| JAYCEE PARK FINAL CONCEPT

CITY COUNCIL MEETING
JULY 24, 2024

What has changed in the final design of Phase I?

“The Reef” Floor Plan

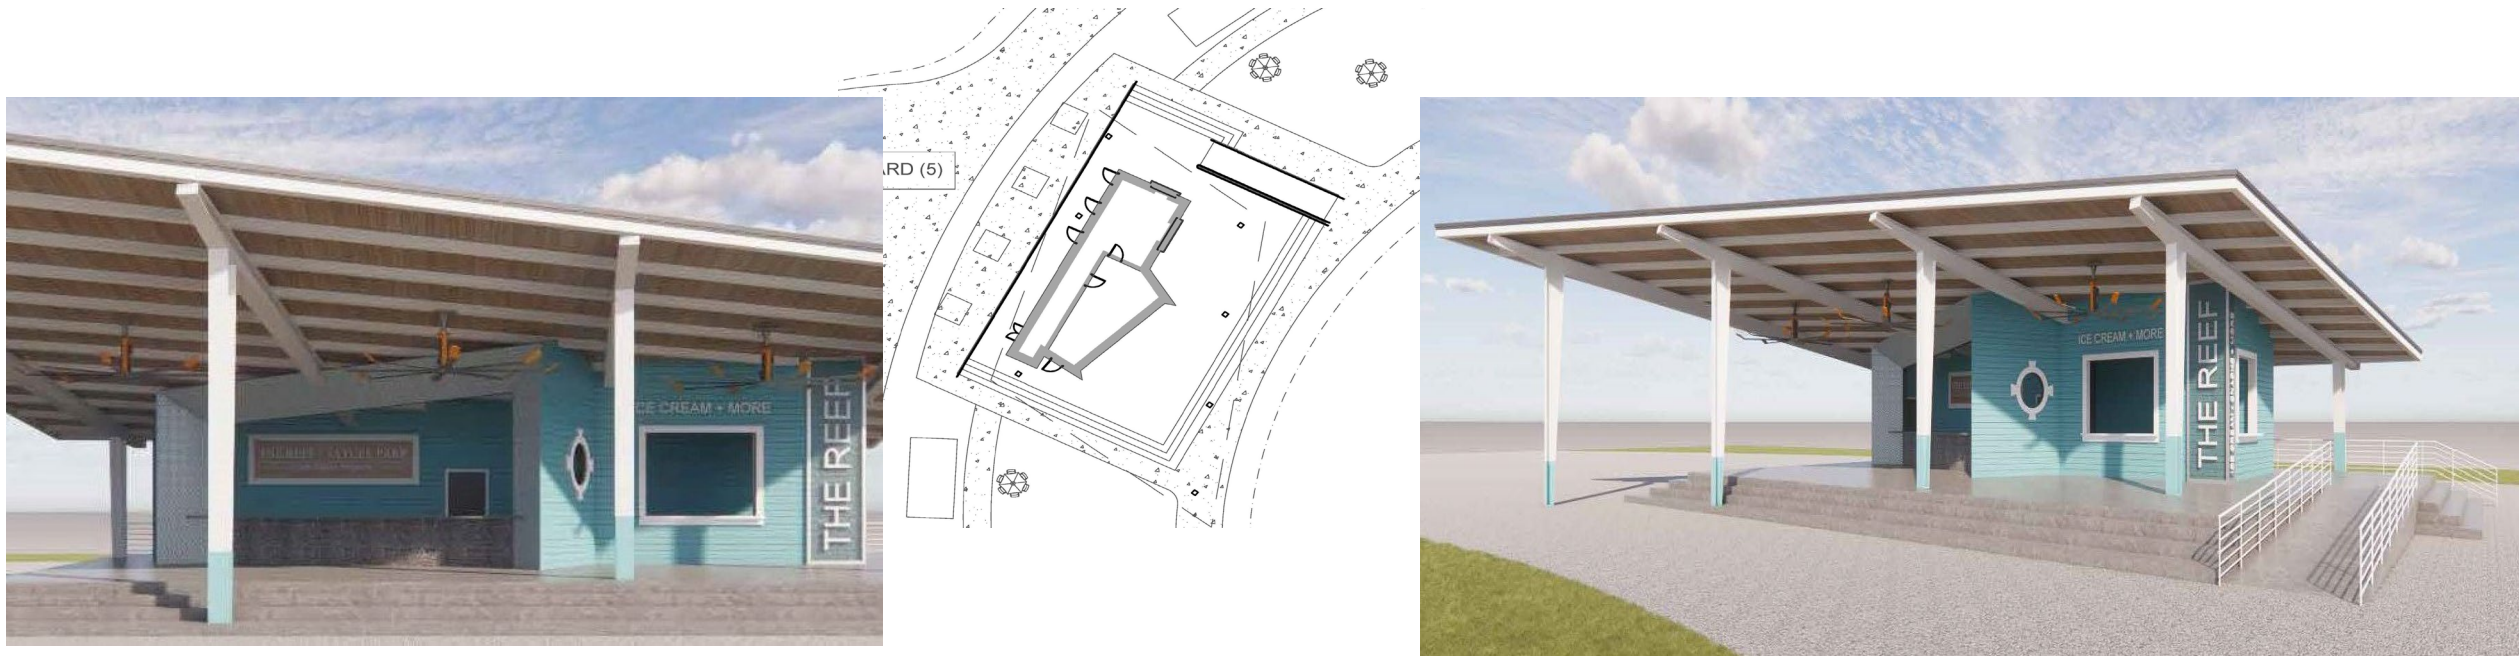
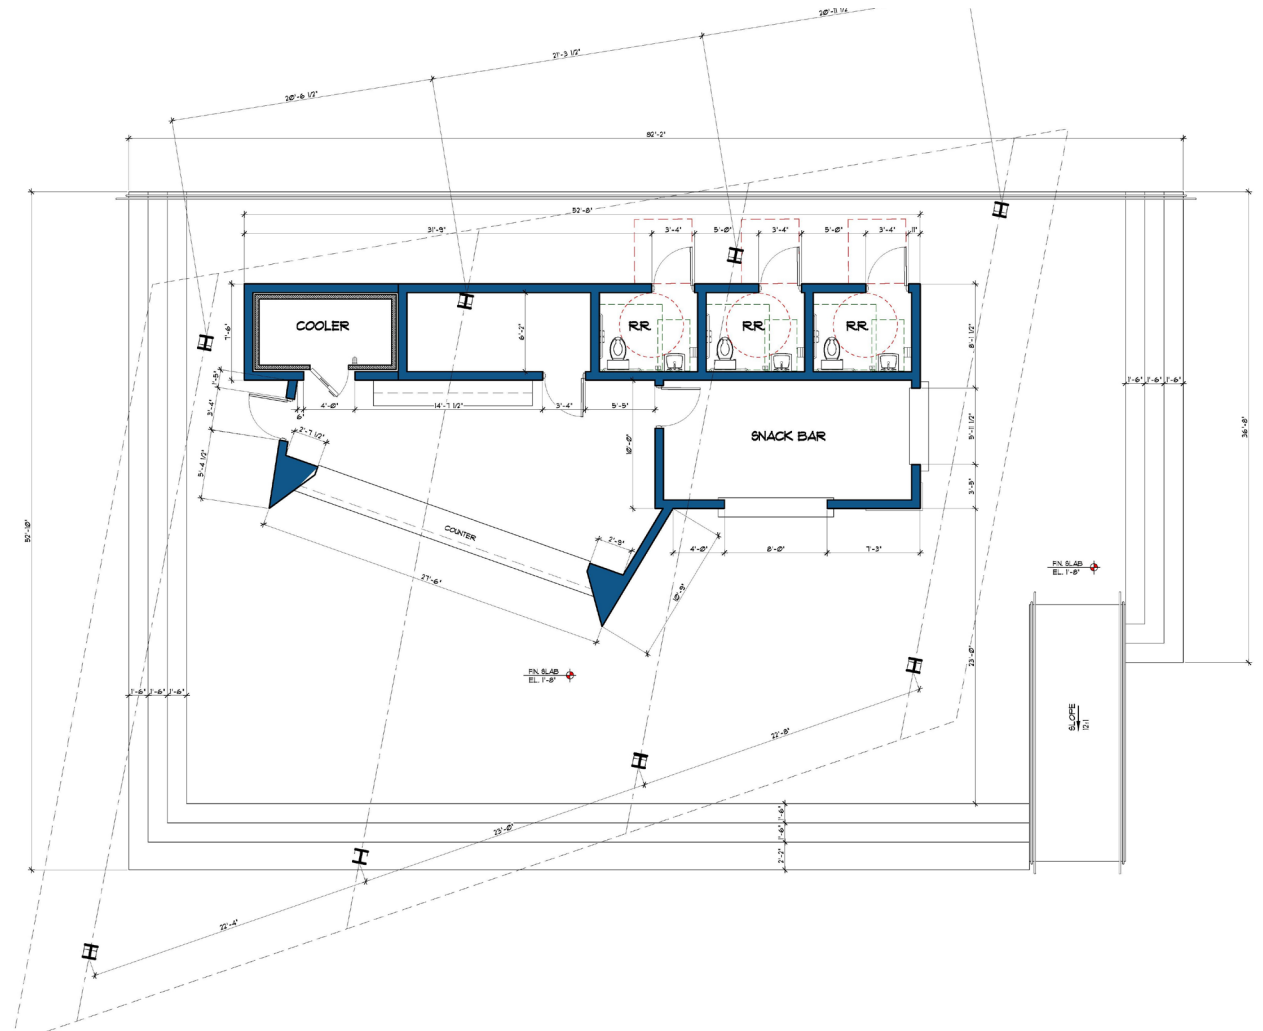
1. *We changed direction on this amenity based on concerns expressed about the image an actual “bar” might present.*
2. *The “Bar/Bistro” as envisioned in the original concept is gone.*
3. *Overall function has been modified and building size significantly reduced.*
4. *The new concept is influenced by the “Spa Beach Bistro” on St. Pete Pier.
 - a. *Spa Beach Bistro is walk-up pizza and beverage service in middle of the pier.*
 - b. *Splash pad and playground are adjacent to the Bistro on east and west sides.**

Here is the original 3,000 sf footprint for the bar and the concepts selected by the participants in the early survey.

Here is the same footprint showing how much space the new structure will occupy with the concepts provided by the P3 group.

1. Building is about 1,000 sf
2. Snack Bar with Ice Cream and Other Treats on Right with Front and Side Service Windows
3. Beverage Counter on Left – No Seats or Stools
4. Walk-Up Service Only
5. A Few Bistro Tables on the Main Level for Patrons to Use
6. Oversized Roof to Provide Shade
7. Three Ceiling Fans to Cool Patrons
8. Three Unisex Restrooms in Back
9. Handicapped Access Ramp

Bandshell Final Design

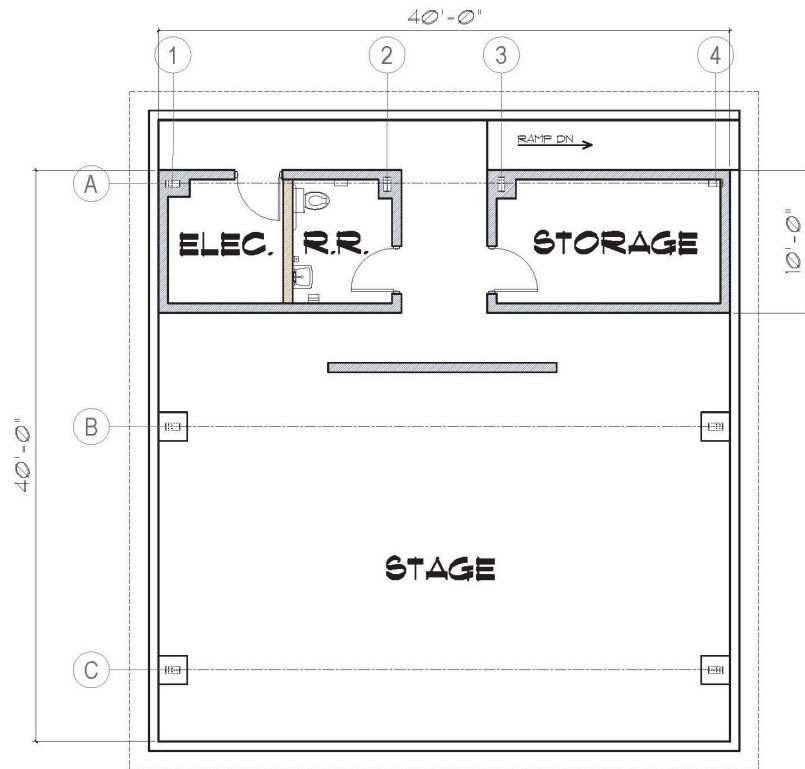
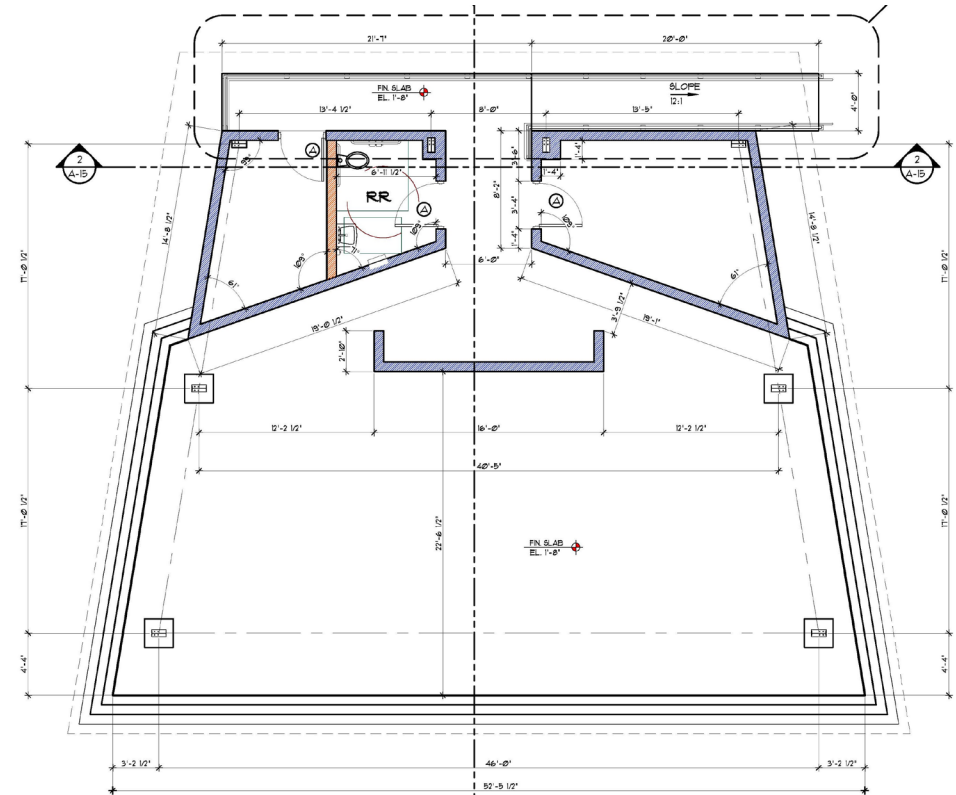
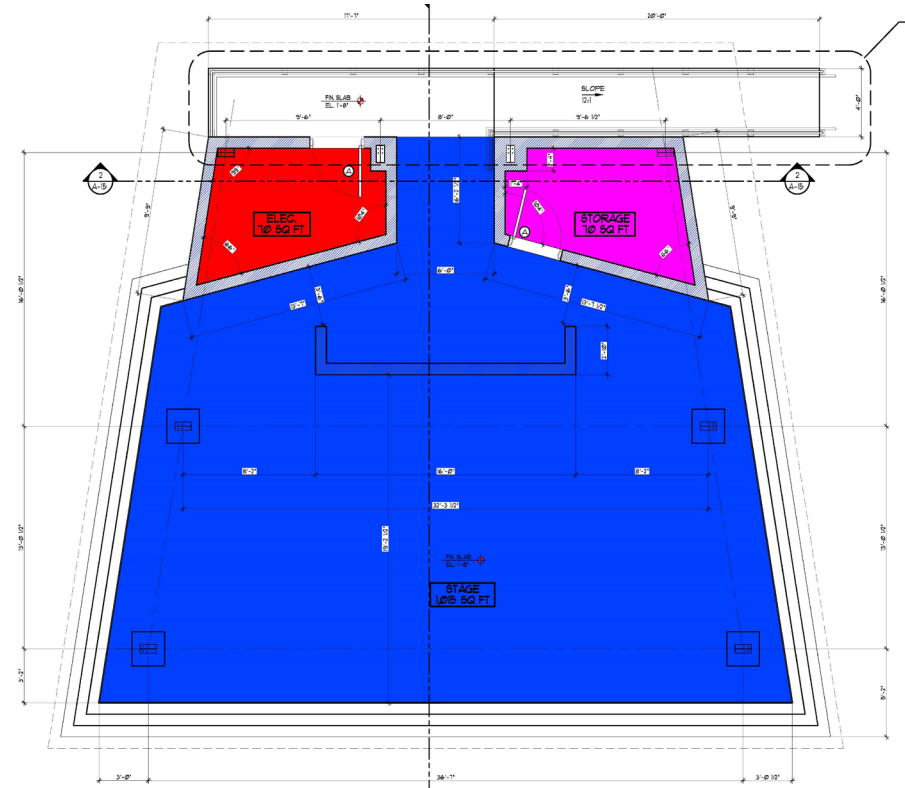
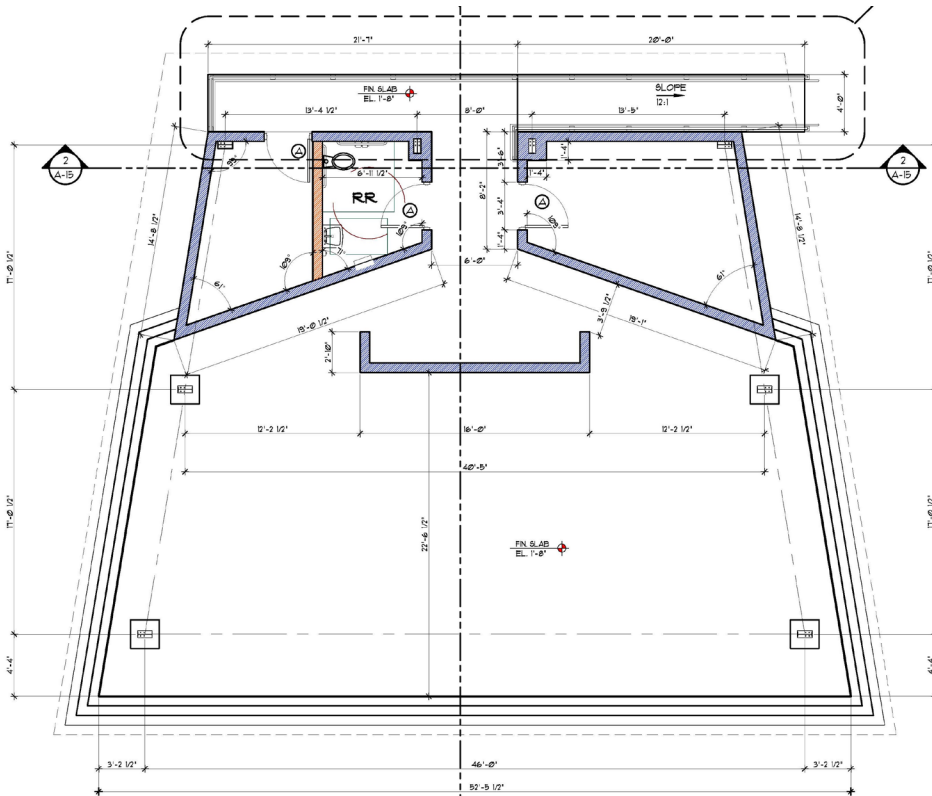
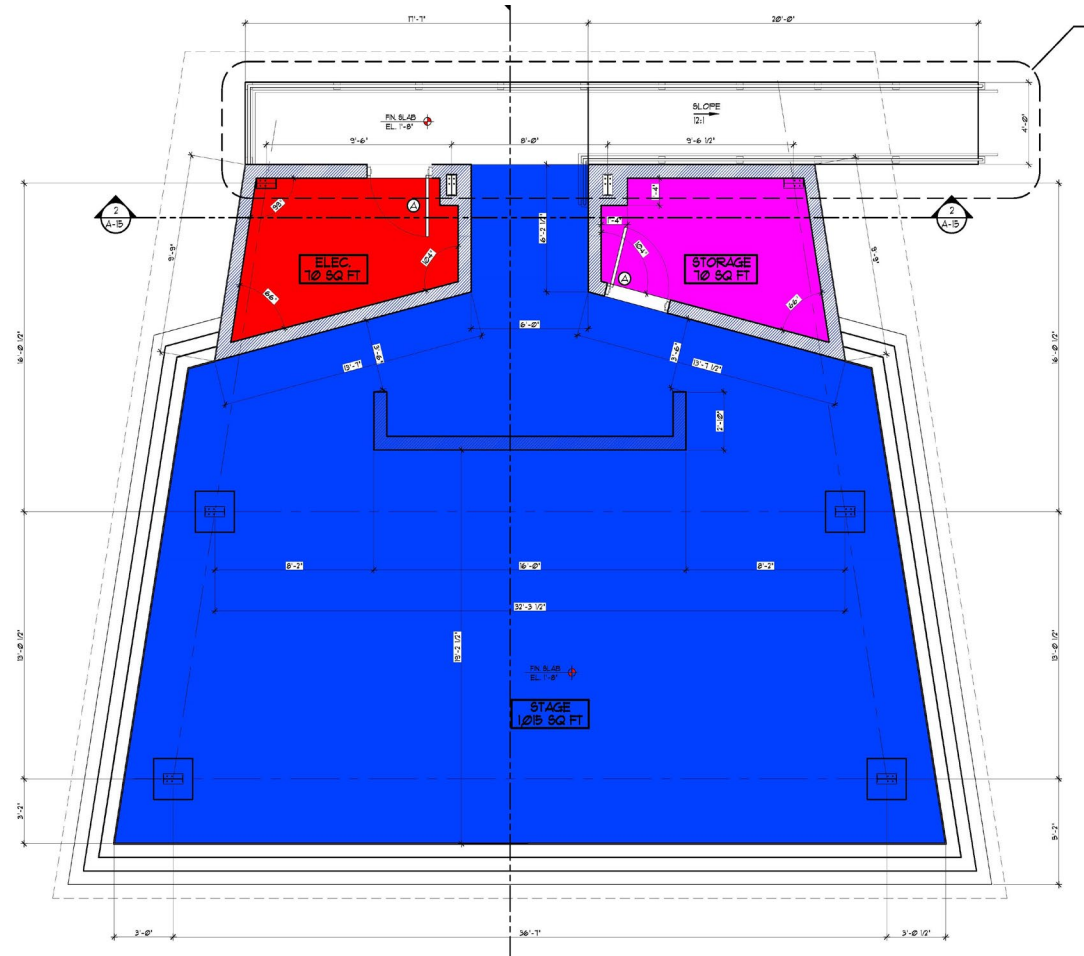
1. *Initial design at 30% showed a 1,600 sf bandshell.*
2. *Public input from the 30% design meeting had several attendees say the structure looked like a glorified pavilion. Based on this feedback, the design was modified to look more like a bandshell, which increased the size to 2,400 sf.*
3. *Following public sentiment that the bandshell now was too big, the structure was redesigned and reduced in size to about 1,200 sf.*

30% Design vs. 75% Design

75% Design vs. Updated 75% Design

1. Bandshell is about 1,200 sf
2. Stage Size: 1,015 sf
3. Restroom Removed
4. Smaller Storage and Electrical Rooms
5. Handicapped Access Ramp

North Restroom Floor Plan

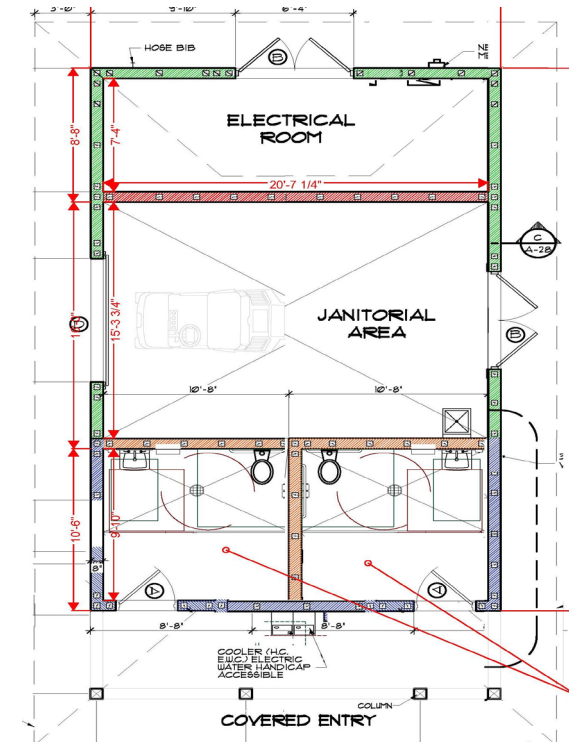
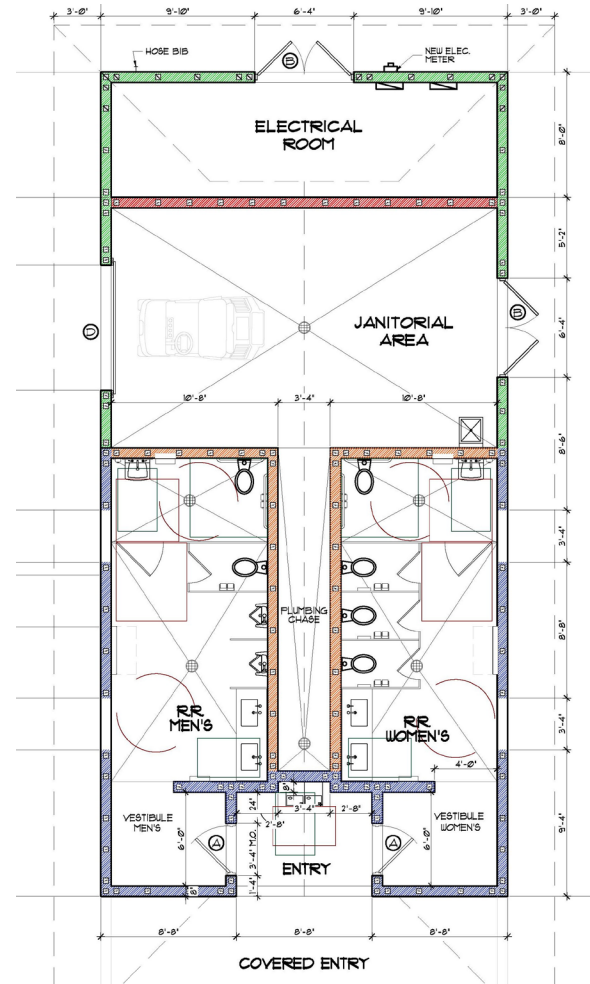
- 1. Initial design provided two, large restroom buildings and The Reef stalls**
 - a. *Jaycee Park currently has two restroom buildings: One with four stalls, one with two stalls – Six total stalls*
 - b. *Design proposed a North restroom building with eight stalls + storage for maintenance*
 - c. *Design proposed a Central restroom building with eight stalls + splash pad pump equipment*
 - d. *The Reef design included three stalls.*

- 2. Public criticism was there were too many restrooms for the amenities**

- 3. City revisited the restroom and reduced the size of the North restroom.**

1. Reduced from eight stalls to two unisex bathrooms.
2. Retained needed maintenance storage and electrical room.
3. Combined with full bathroom facility in central location and three unisex stalls at *The Reef*, total stalls at Jaycee will be 13.
